**ZONING AMENDMENT (*Holdover*),  
PLANNED UNIT DEVELOPMENT &  
SUBDIVISION STAFF REPORT**

**Date: June 1, 2017**

<b><u>NAME</u></b>	O. A. Pesnell, Jr.
<b><u>SUBDIVISION NAME</u></b>	Addison Woods Subdivision
<b><u>LOCATION</u></b>	3450 Girby Road (North side of Girby Road 160'± East of Hillcrest Road)
<b><u>CITY COUNCIL DISTRICT</u></b>	District 6
<b><u>PRESENT ZONING</u></b>	B-1, Buffer-Business and B-3, Community Business
<b><u>PROPOSED ZONING</u></b>	B-1, Buffer-Business
<b><u>REASON FOR REZONING</u></b>	To eliminate split zoning.
<b><u>AREA OF PROPERTY</u></b>	3 Lots / 16.3 ± Acres
<b><u>CONTEMPLATED USE</u></b>	Subdivision approval to create 3 lots, Planned Unit Development Approval to allow multiple buildings on a single building site, and Rezoning from B-1, Buffer-Business District, and B-3, Community Business District, to B-1, Buffer-Business District, to eliminate split zoning. <b>It should be noted, however, that any use permitted in the proposed district would be allowed at this location if the zoning is changed. Furthermore, the Planning Commission may consider zoning classifications other than that sought by the applicant for this property.</b>

# DETAIL SITE PLAN

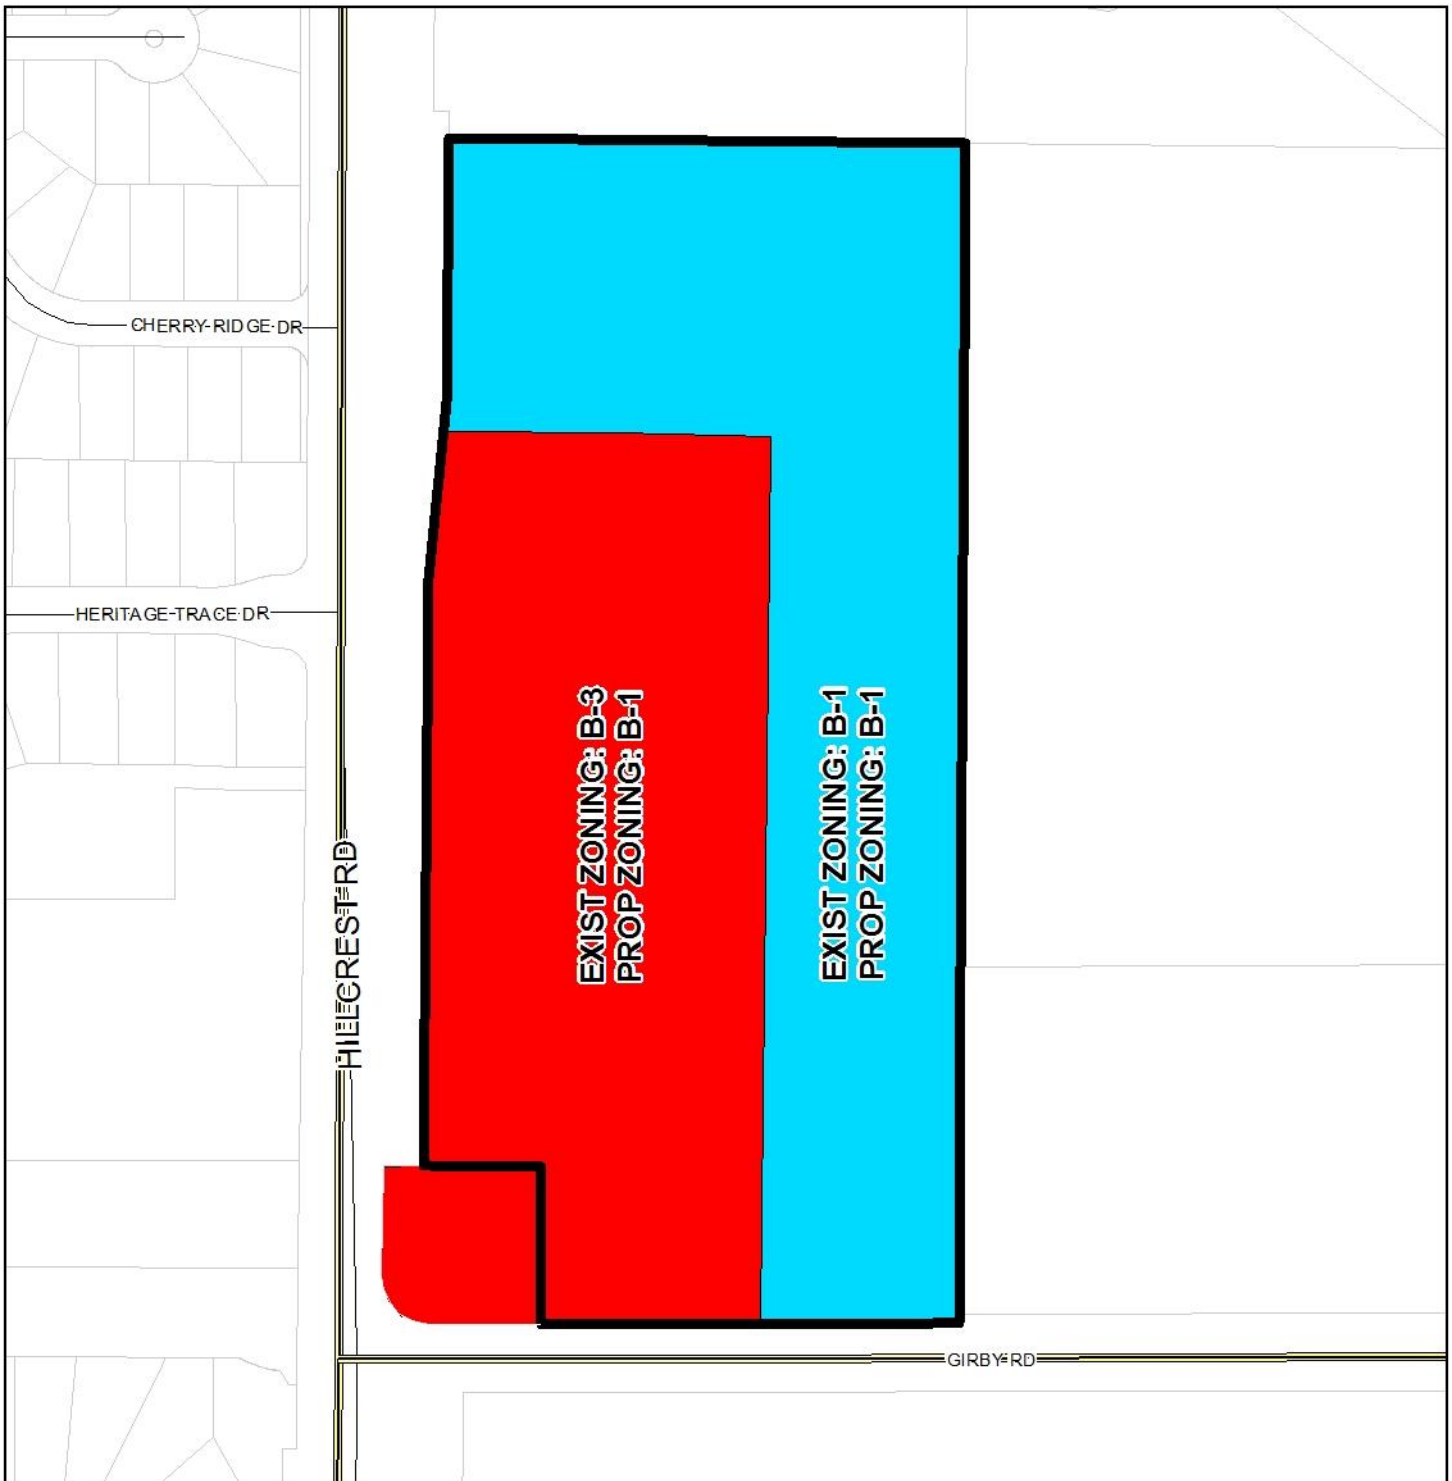
The site has frontage on two streets that are part of the Major Street Plan: Hillcrest Road and Girby Road. Each proposed major street requires a minimum right-of-way width of 100 feet, and it appears that the right-of-way for Hillcrest Road meets the minimum requirements. The right-of-way width of Girby Road is labeled as 80 feet on the preliminary plat, thus dedication to provide 50 feet from the centerline will be required. Right-of-way dedication will impact all three proposed lots, thus the lot sizes and the minimum building setback lines should be revised to reflect the dedication of right-of-way along Girby Road.

The Planned Unit Development site plan depicts 28 "garden cottages," each approximately 1,200 square feet in size, and two assisted living facilities, one of which is designated to be a "specialty care" facility. The assisted living facilities appear to contain 20 beds each, for a total of 40 beds, according to information on the site plan. Regarding parking, ten combined spaces are required for the assisted living facilities, and two spaces are required for each garden cottage: the applicant proposes 97 parking spaces, well in excess of the 66 required. Due to the type of

The site plan indicates that the private road serving the proposed development on Lot 3 will only access Girby Road. Due to the fact that Girby Road is a major street, and the proximity of the intersection with Hillcrest Road to the West and Burns Middle School to the East, the two proposed commercial lots (Lots 1 and 2) should be denied direct access to Girby Road, and instead should be limited to one curb-cut onto the private road. Direct access to Hillcrest Road for Lot 3 should be denied, primarily due to the presence of a large area of designated wetlands. The size, design and location of any curb-cuts must be approved by Traffic Engineering and comply with AASHTO standards.

It appears that fire access to the property may be sufficient, however, the applicant should ensure that there is sufficient turn-around area for a fire apparatus.

Also, it should be noted that no dumpsters are depicted on the site plan, however, if provided, they must be installed in compliance with 64-4.D.9. of the Zoning Ordinance.

As more than 25 parking spaces will be provided in the vicinity of the two assisted living facilities, a photometric plan for that portion of the site will be required at time of land disturbance. Lighting of the site will have to comply with Sections 64-4.A.2., 64-6.A.3.c. and 64-6.A.8. of the Zoning Ordinance.

- 1) Dedication of right-of-way along Girby Road to provide 50-feet from centerline;
- 2) Revision of the lot size and minimum building setback information to reflect right-of-way dedication;

- 3) Placement of a note on the site plan stating that Lots 1 and 2 are denied direct access to Girby Road, and are limited to one curb-cut each to the private drive on Lot 3, that Lot 3 is limited to one curb-cut to Girby Road and denied direct access to Hillcrest Road, with the size, design and location of curb-cuts to be approved by Traffic Engineering and comply with AASHTO standards;
